**CITY OF MERIDIAN
FINDINGS OF FACT, CONCLUSIONS OF LAW
AND
DECISION & ORDER**

In the Matter of the Request for Conditional Use Permit for a Multi-family Development Consisting of 516 Residential Units (364 Apartments, 126 Flats and 26 Townhome Style Units) on 19.34-acres of Land in the R-40 and C-C Zoning Districts for Outer Banks Apartments, Generally Located off the Southwest Corner of W. Franklin Rd. and S. Ten Mile Rd. in the NE ¼ of Section 15, T.3N., R.1W., by J-U-B Engineers.

Case No(s). H-2024-0026

STAFF REPORT COMMUNITY DEVELOPMENT DEPARTMENT

B. Landscape Plan & Open Space Exhibit (dated: 9/17/24)

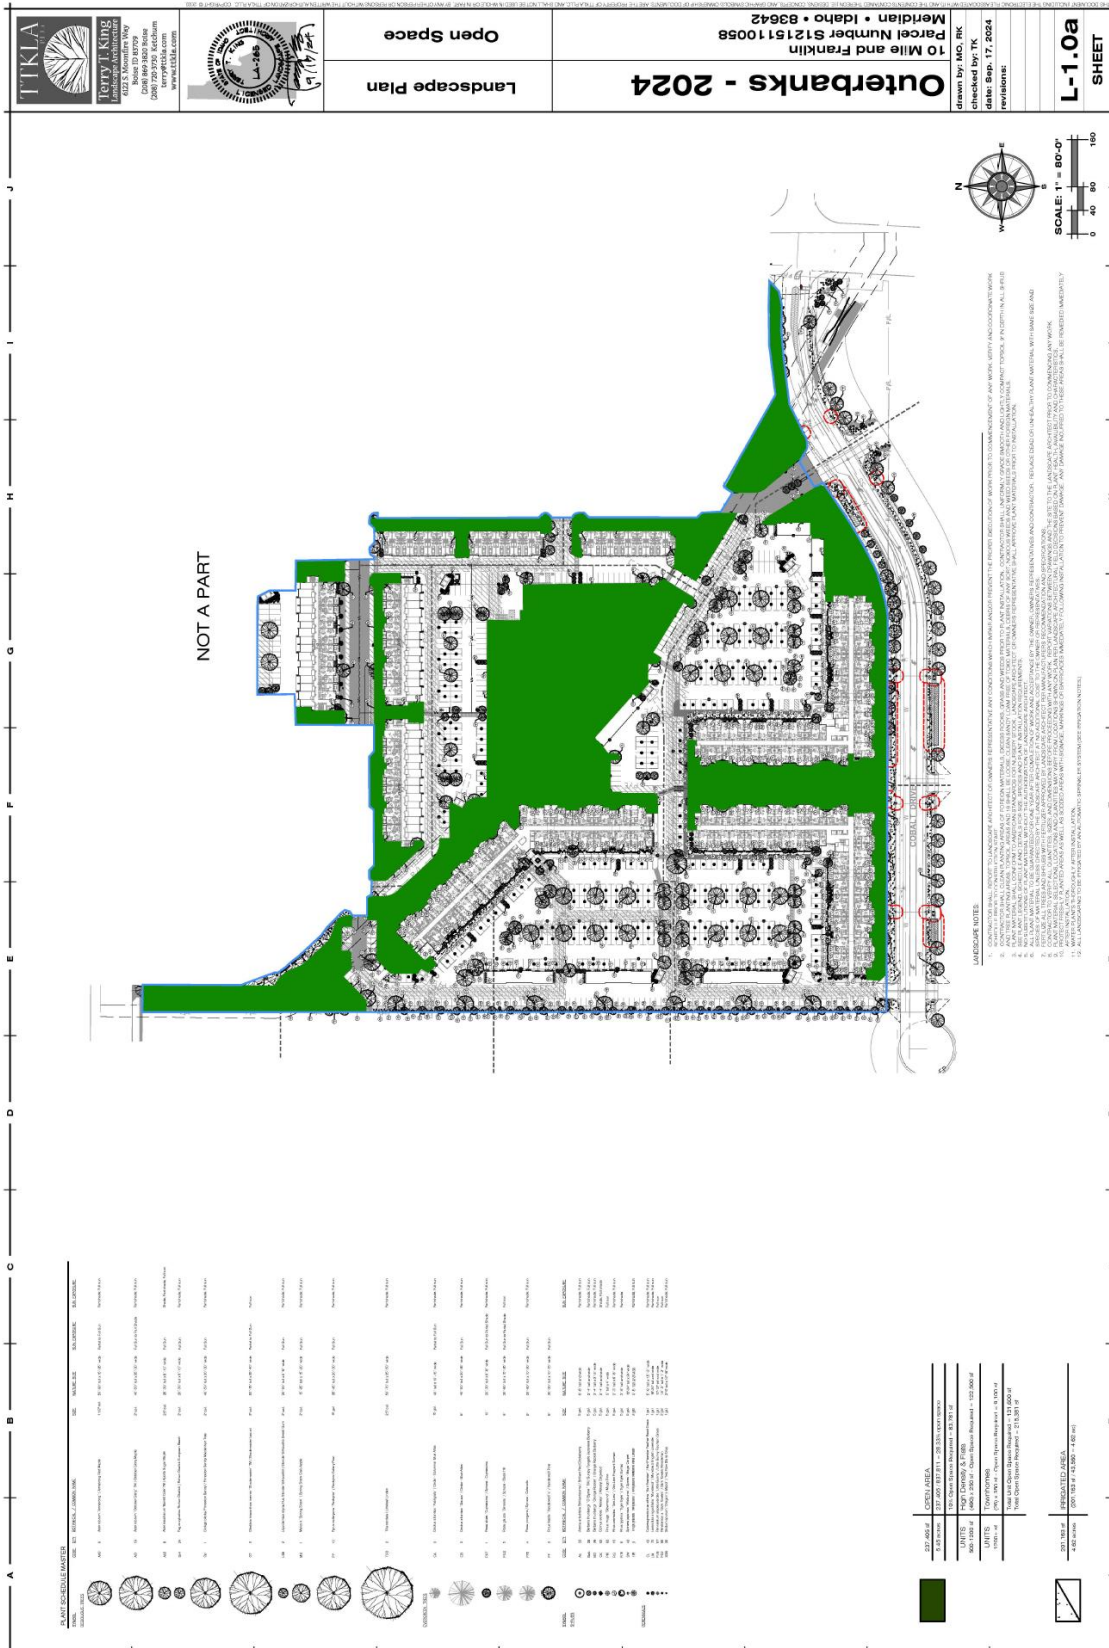
8. Unless otherwise approved through the conditional use process, common open space areas shall not be adjacent to collector or arterial streets unless separated from the street by a berm or constructed barrier at least four feet (4') in height, with breaks in the berm or barrier to allow for pedestrian access. (Ord. 09-1394, 3-3-2009, eff. retroactive to 2-4-2009) ***Some of the common open space areas are adjacent to the collector street buffer along Cobalt Dr. Staff recommends the Applicant provide a berm or constructed barrier as required.***

The common open space exhibit depicts the street buffer along W. Cobalt Dr., a collector street, as part of the required open space. **Therefore, the buffer shall comply with the enhanced buffer requirements as noted.**

The landscape plan submitted with the Certificate of Zoning Compliance application should depict landscaping along the street facing elevations in accord with these standards. A calculations table should be included on the landscape plan that demonstrates compliance with this standard. There are several plants/shrubs/trees that are called out on the plan that aren't included in the plant legend (i.e. SK, POL, PO, BH, etc.); revise accordingly.

Parking lot landscaping is required in accord with the standards listed in UDC 11-3B-8C. **No linear grouping of parking spaces is allowed to exceed 12 in a row without an internal planter island; the planter island is required to run the length of the parking space and may be reduced by 2' to allow for improved vehicle maneuvering. Landscape planters are required to contain a minimum of 50 square feet and the planting area can't be less than 5' in any dimension, measured inside curbs. There are some rows of parking that are missing these planters and others that have only 5'6" x 5'6" planters, which don't meet the standard; the plans should be revised accordingly to comply or an application for alternative compliance to this standard may be submitted (see UDC 11-5B-5 for more information).**

Landscaping is required to be provided along pathways per the standards listed in UDC [11-3B-12C](#). **A mix of trees, shrubs, lawn and/or other vegetative ground cover with a minimum of one (1) tree per 100 linear feet of pathway is required all pathways. A calculations table should be included on the landscape plan that demonstrates compliance with this standard.**

- i. Depict landscaping along the foundations of all street facing elevations in accord with the standards listed in UDC [11-4-3-27E.2](#). A calculations table should be included on the landscape plan that demonstrates compliance with this standard.

- j. There are several plants/shrubs/trees that are called out on the plan that aren't included in the plant legend (i.e. SK, POL, PO, BH, etc.); revise accordingly.

- k. Include a detail of the fire pits, barbeques and children's play structure.
 - l. Depict planter islands in rows of parking in accord with the standards listed in UDC 11-3B-8C.2.; or submit an application for alternative compliance to this standard (see UDC 11-5B-5 for more information).

- n. Include a detail of the trash enclosure that demonstrates compliance with UDC 11-3A-12 and 11-4-3-27B.2.
 - o. The street buffer along W. Cobalt Dr. shall comply with the enhanced buffer requirements listed in UDC 11-4-3-27C.9 and 11-3B-7C.3f.
